### UNITED STATES PATENT AND TRADEMARK OFFICE

APPLICATION NO.	FILING DATE	FIRST NAMED INVENTOR	ATTORNEY DOCKET NO.	CONFIRMATION NO.
09/530,156	08/31/2000	Oliver Hecker	AP9472	3844
10291	7590 04/18/2002			
RADER, FISHMAN & GRAUER PLLC 39533 WOODWARD AVENUE SUITE 140			EXAMINER	
			BURCH, MELODY M	
BLOOMFIELD HILLS, MI 48304-0610		J610	ART UNIT	PAPER NUMBER
			3683	
			DATE MAILED: 04/18/2002

#### **DETAILED ACTION**

Fig. 8

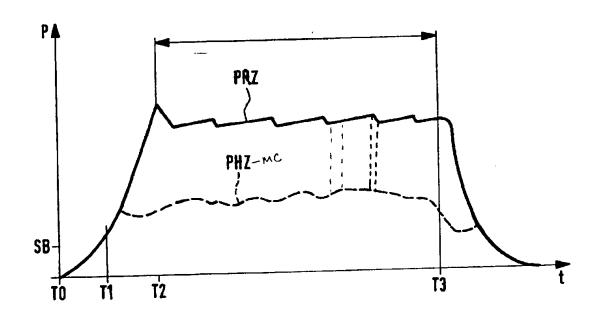
Re: claims 1, 10, 11, 14, and 17-19. DE-19501760 shows in figure 8 a method of operating a brake assist system which comprises a first mode shown from T0 to T1 in which the brake assist system is not actuated, a second mode of operation shown from T1 to T3 and disclosed in col. 9 lines 32-36 in which after recognition of an emergency brake situation (the exceeding of a threshold) a pressure build-up of wheel brakes is generated, and a third mode of operation shown from T3 to the end of the x-axis and

Re: claim 13. It is inherent that the ratio of the wheel brake pressure and the master brake cylinder pressure is equal to some time dependent constant of proportionality or momentary value as evident from the plot of figure 8.

Re: claim 15. Pueschel et al. show in the area of the red perforated lines of the attached copy of figure 8 the limitation of declining the excess elevation function in time intervals in which the master cylinder pressure is declining as evident by the sharper decrease in the wheel brake pressure compared to the master cylinder pressure.

5. Claim 16 is rejected under 35 U.S.C. 103(a) as being unpatentable over DE-19501760 in view of US Patent 4798422 to Becker. Pueschel et al. show in the area of the grey perforated lines of the attached copy of figure 8 time intervals in which the master cylinder pressure is increasing. Although the wheel brake pressure is increasing in this interval as well, it is not disclosed or shown that the excess elevation function is kept constant in this time interval. Becker teaches in col. 5 lines 18-26 the use of brake control apparatus in which the wheel brake pressure is determined as a function of the master cylinder pressure and in which the pressure difference between the wheel brake pressure and the master cylinder pressure is monitored. It would have been obvious to one of ordinary skill in the art at the time the invention was made to have modified the system of Pueschel et al. with an interval in which the wheel brake pressure is directly proportional to the master cylinder pressure such that a wheel brake pressure increase mirrors a master cylinder brake pressure increase, in view of the teachings of Becker, in order to achieve a desired brake actuating comfort level.

Re: claim 13. Examiner maintains that a momentary value of the wheel brake pressure PRZ is determined by multiplying a momentary value of a time-dependent excess elevation function with the momentary value of the master cylinder pressure PHZ during the portion of the third mode of operation immediately before the point where the master cylinder pressure PHZ increases. The claim does not require that the sub step of determining the momentary value be done over the duration of the third mode.
